MILITARY SPECIFICATION SHEET

ELECTRON TUBE, STORAGE

TYPE 7571

This amendment forms a part of Military Specification Sheet MIL-E-1/1563, dated 15 December 1964, and is mandatory for use by all Departments and Agencies of the Department of Defense.

Figure 1. Outline drawing of electron tube type 7571.

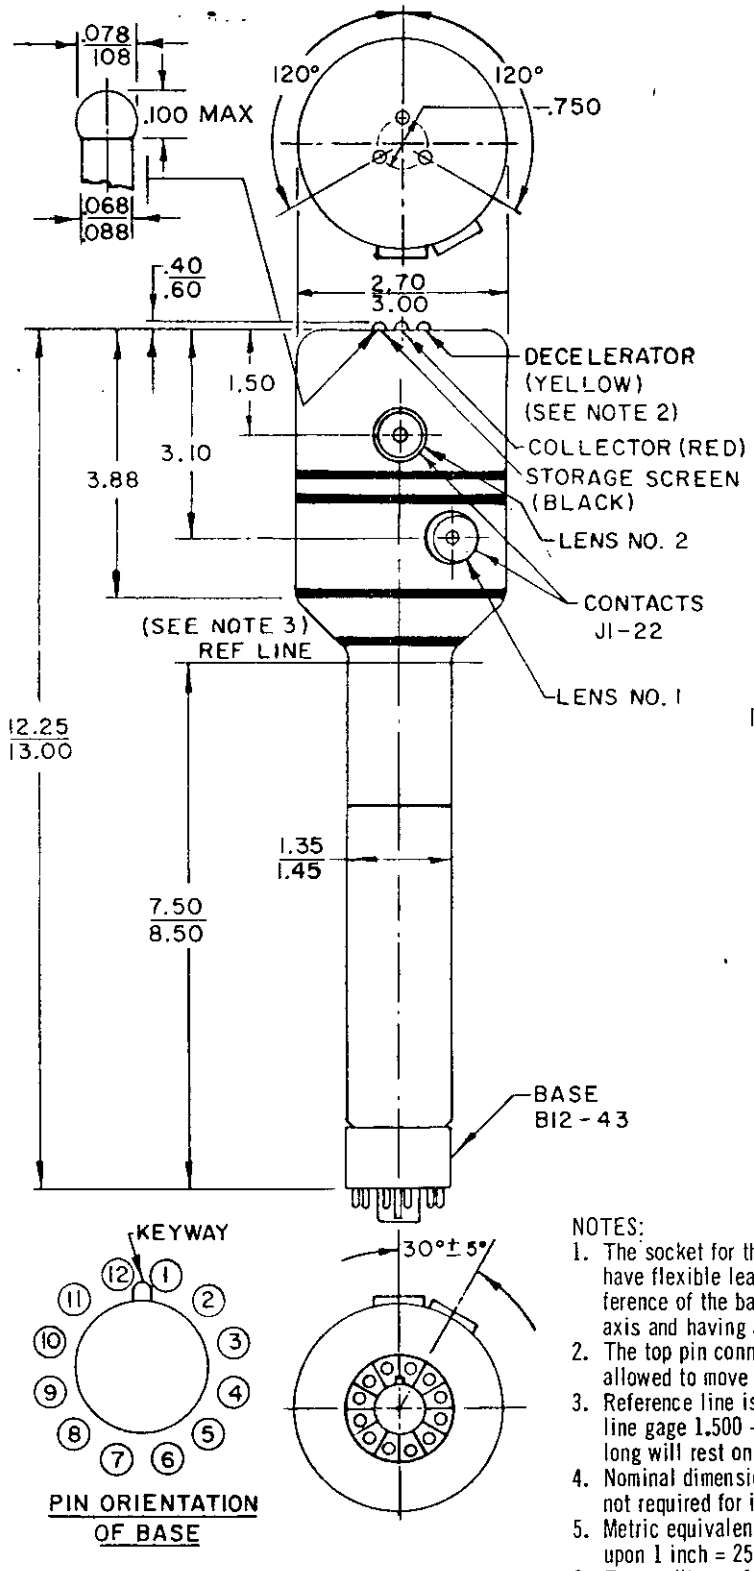
Page 8: Delete "Figure 1" and substitute the attached new "Figure 1."
